AGENDA
Work Session
San Luis City Council
Council Chambers
1090 E. Union Street
San Luis, AZ 85349
December 4, 2024
6:00 p.m.

2. B. Discussion on possible directions to staff on any and all matters regarding a proposed Development Agreement between the City of San Luis, Arizona, Von Verde Partners LLC, Somerton School District No. 11, and Yuma Union High School District No. 70 for the development of property located between Avenue E and Avenue D and between County 24th Street and County 24 1/2 Street. **(Jose A. Guzman, Director of Development Services)**

The latest draft of the development agreement, along with comments from the Assistant City Attorney dated November 13, 2024, is attached. Staff is awaiting the developer's attorney's response to these comments. While staff's position remains focused on protecting the City and ensuring consistency, Council may choose to impose additional conditions or amend the terms of the agreement.

Exhibit "G"
Conceptual Roadway Master Plan

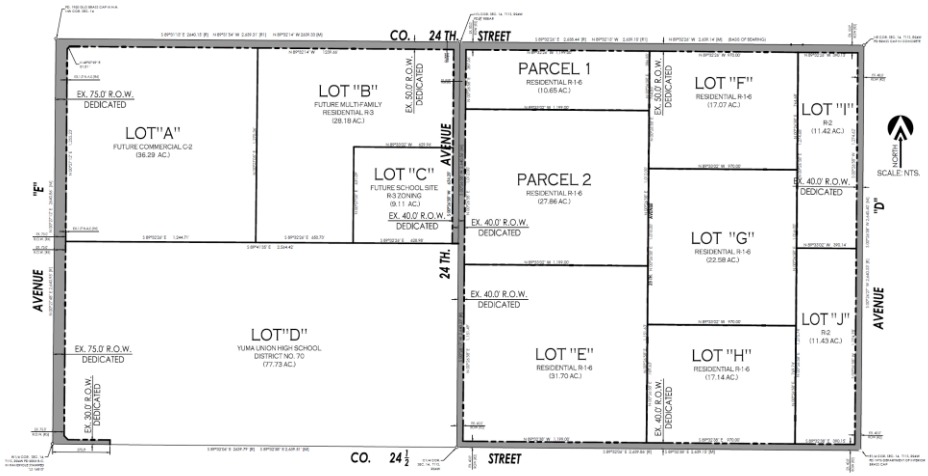
Commented [MM7]: We can ensure the Master Roadway Infrastructure Plan does not result in "scalloped streets"; however, we cannot ensure full-streets to arterial intersections, as such a requirement would require ROW dedication(s) from other properties not subject to this Development Agreement.

Commented [GG9]: With respect to right of way dedication language at 5.7. Needs to provide for FULL dedication not half street for 24th Ave. May require your client to get dedication from YUHS District, and that may have some interesting problems with respect to restrictions on public school districts transferring interests in property, but that is viewed as Von Verde's problem when it transferred an interest in property without a true legal lot split.

Roadway Infrastructure Plan must not allow for "scalloped streets". The Master Roadway Infrastructure Plan shall be consistent with the Conceptual Roadway Master Plan in **Exhibit F**, provided that **Exhibit F** does not allow for "scalloped streets".
